ADDENDUM NO. 2

DATE: September 8, 2016
FROM: City of Grand Junction Purchasing Division
TO: All Offerors
RE: Construction and Site Work for the Las Colonias Park Amphitheater
IFB-4278-16-DH

sheet:
PL401

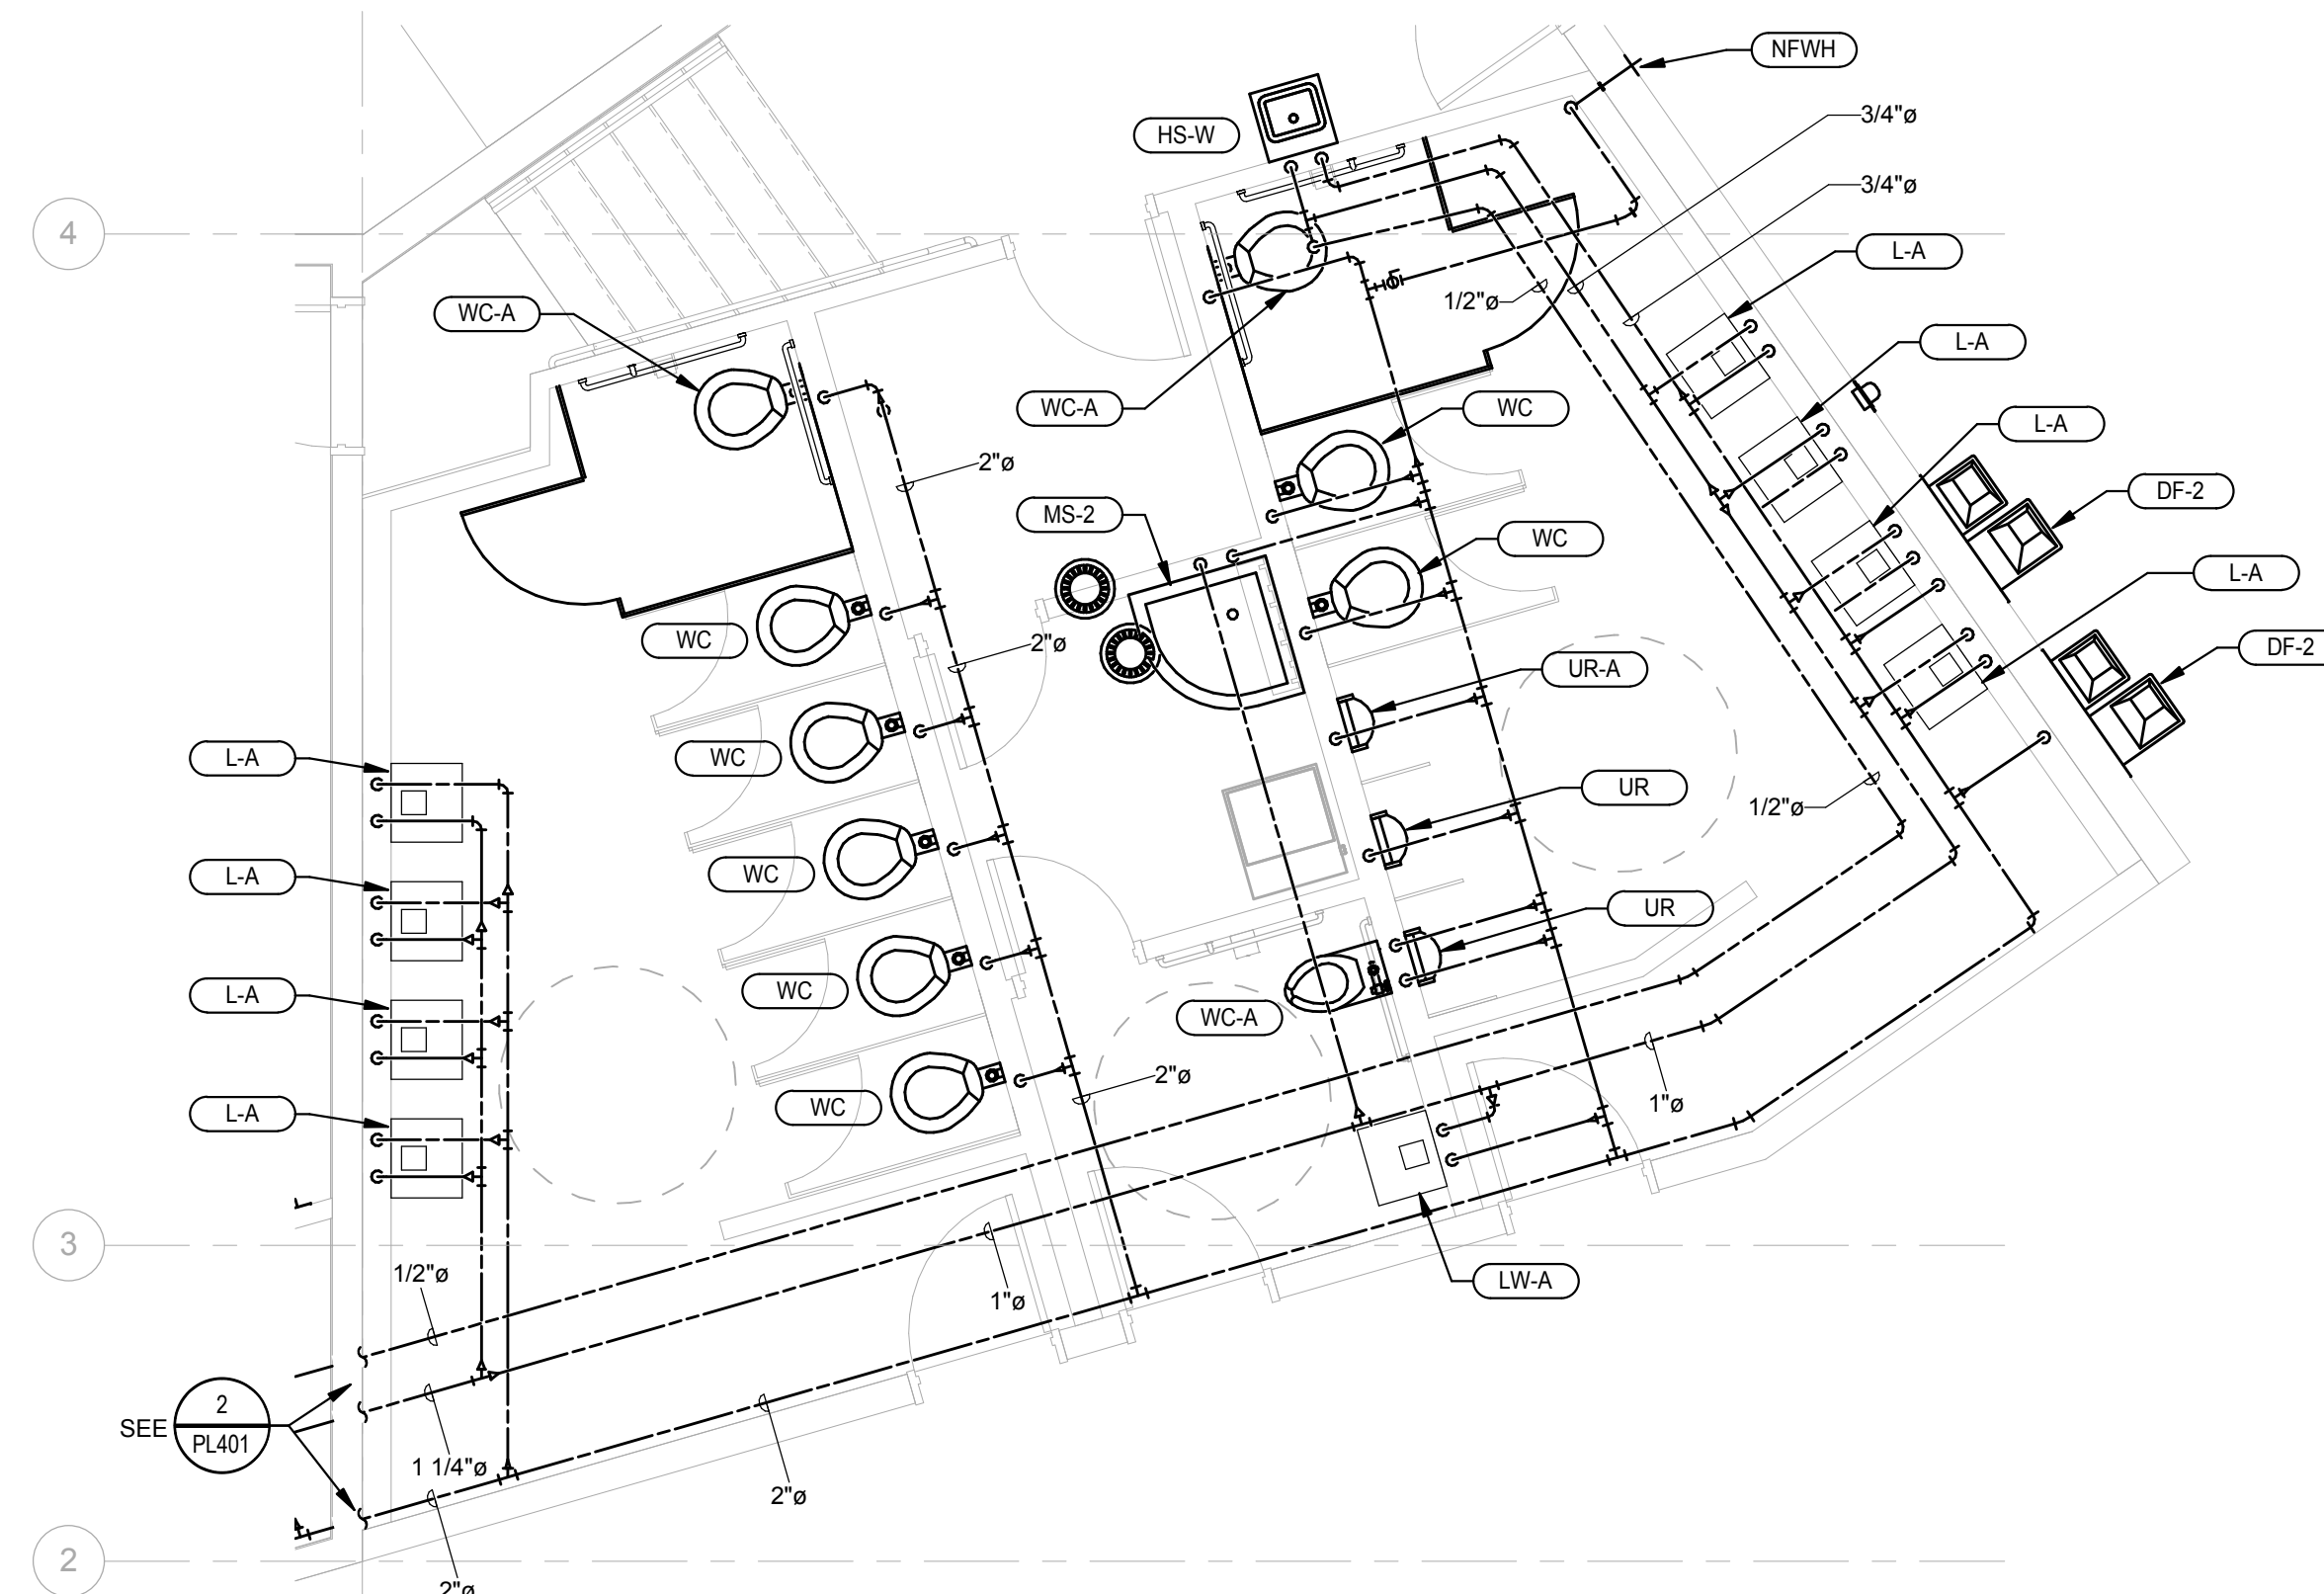
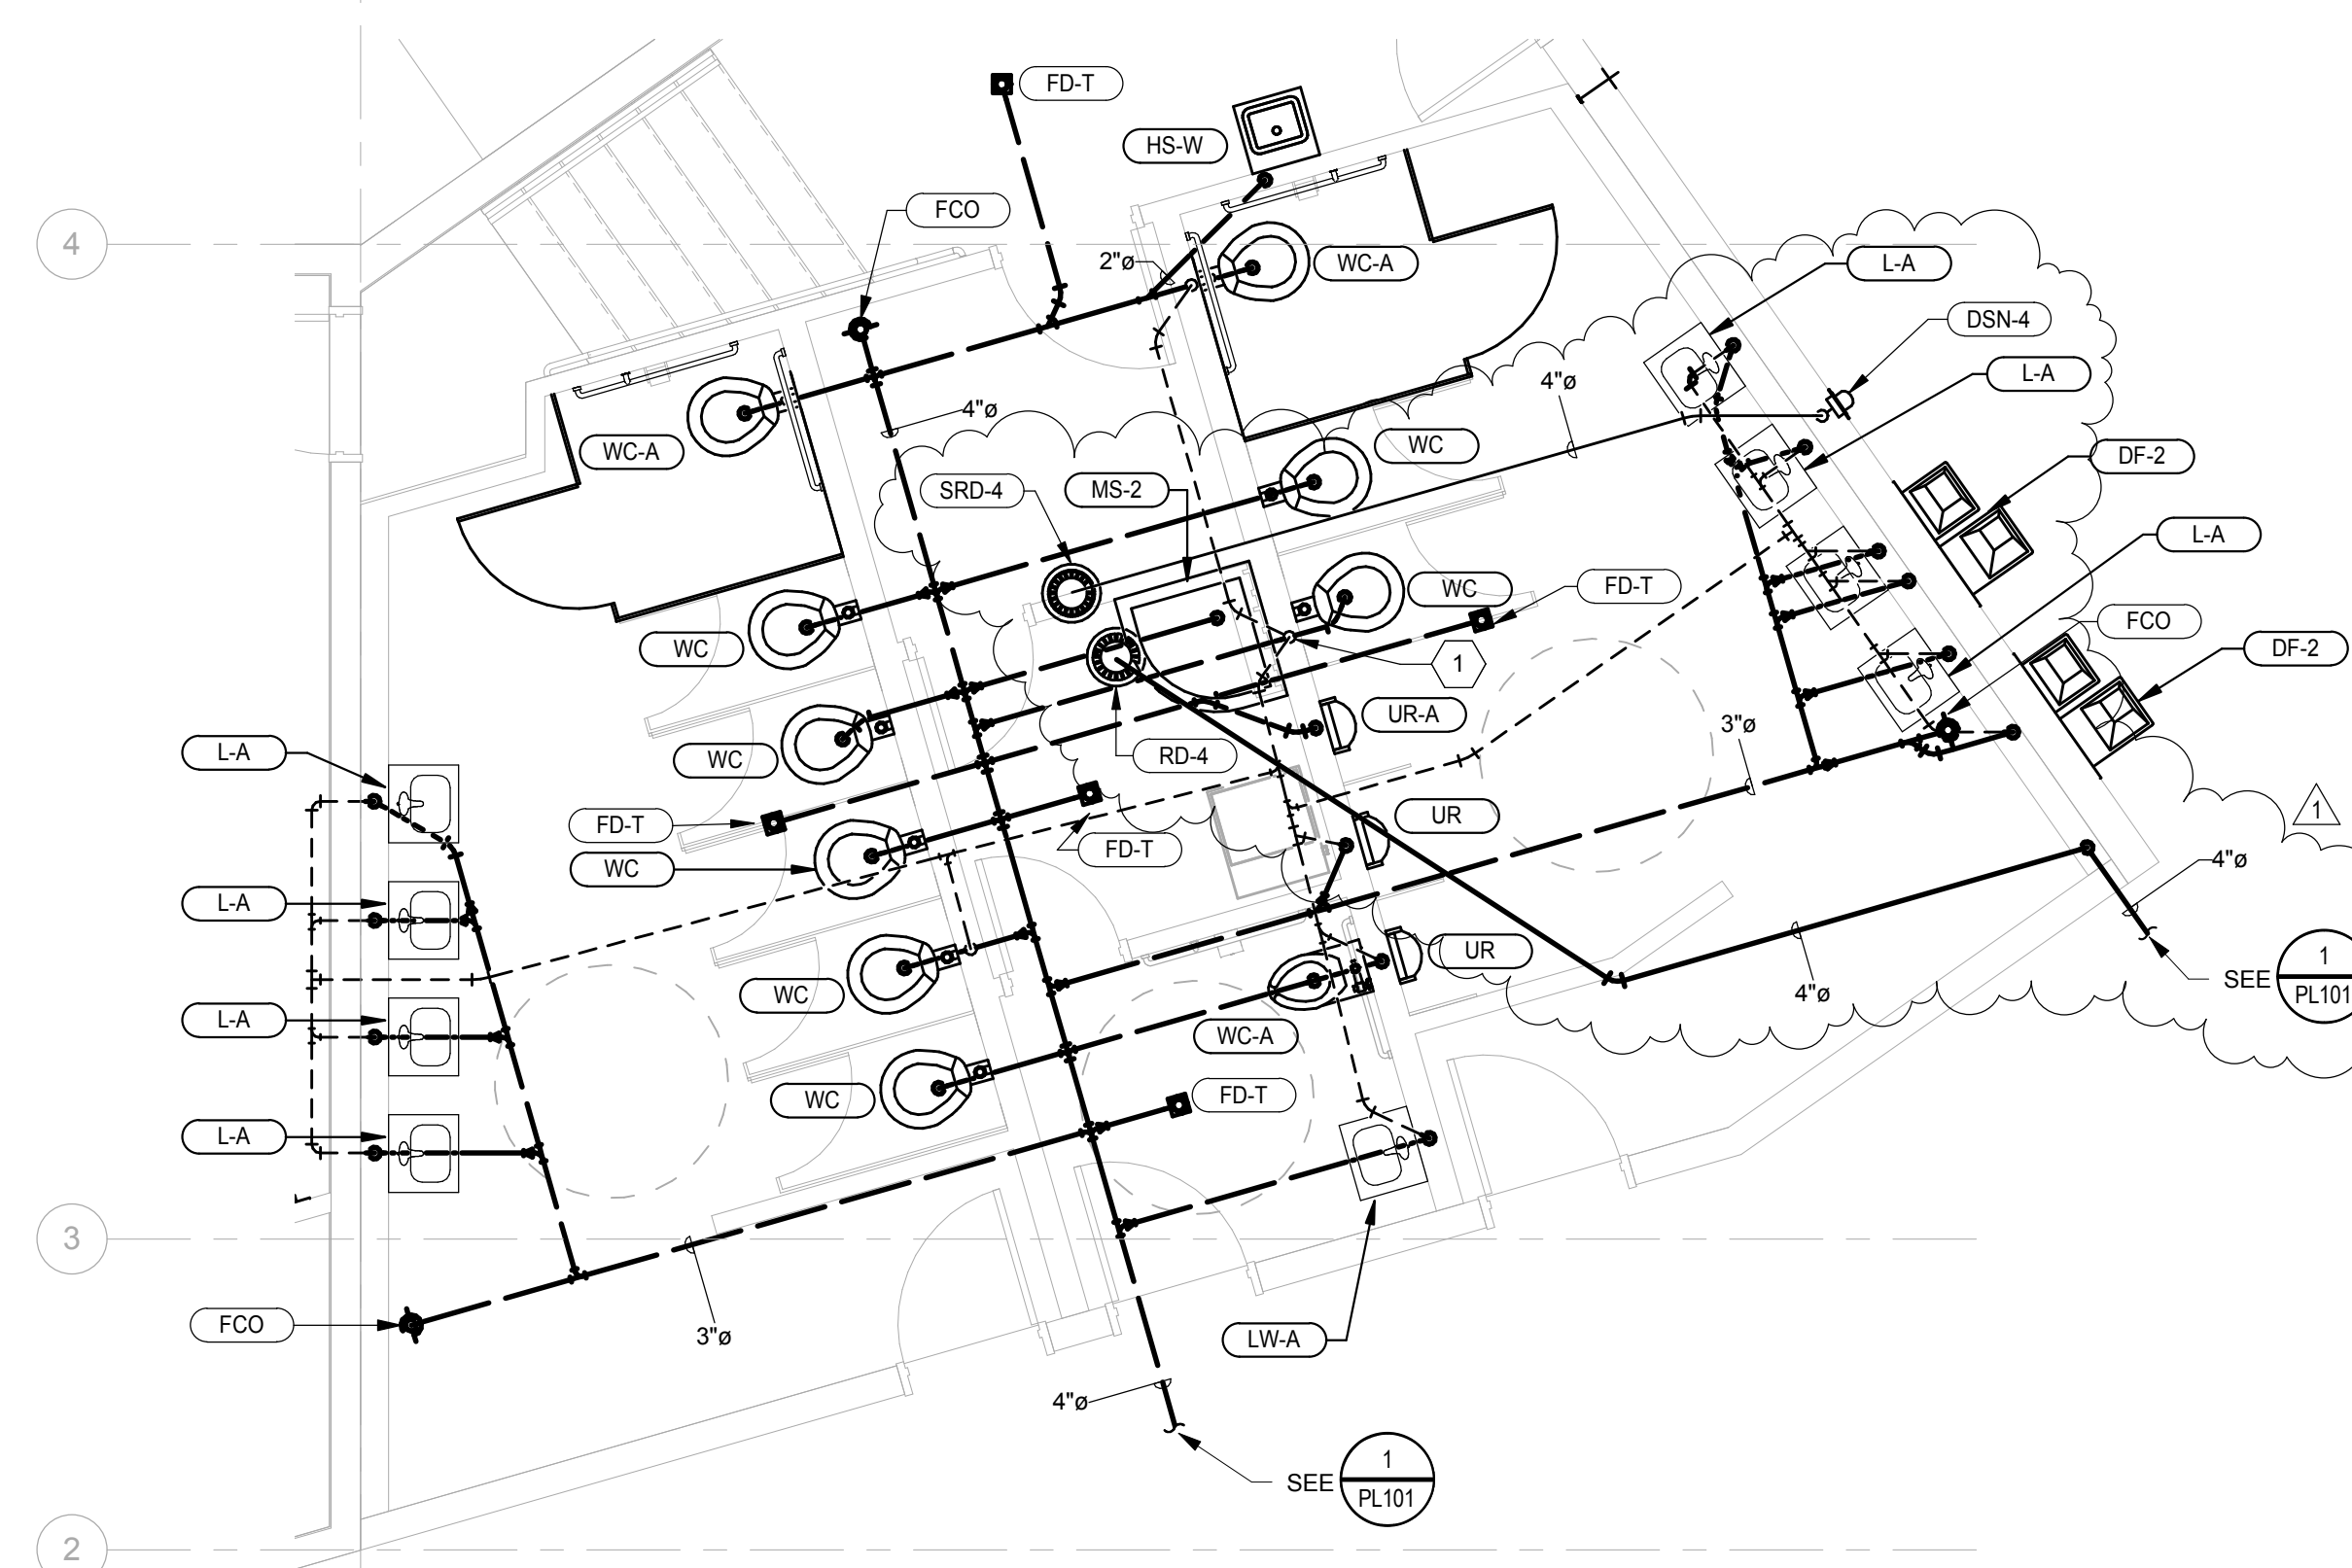
42. PL101 There are 2 additional roof drain location along Gird Line 1 that the plumbing plans only show the roof drain and have no overflows called out. Please confirm.

50. PL401 The piping for the domestic hot water recirculation has the two recirculation lines tee'd together and ball valves shown installed at that location. Shouldn't there be balance valves or circuit setters installed at these two locations? Please clarify.

A. A Secondary roof drain "SRD-4" should be provided adjacent to "RD-4" at grid B-1 and, at grid C-1. (2 locations). A 4" secondary rain water pipe should extend from the ""SRD-4"" and extend through exterior wall at grid 1, near the roof, and terminate with a downspout nozzle "DSN-4". **See revised drawing PL101 & PL401.**

- A. Ball valves shown in DHW recirculation line should be called out as balancing valve "BV" as scheduled on drawings PL602.
51. Please provide the detail for the "sway bracing" called for on the 4" and larger piping per pipe hanger note #8 on PE002.
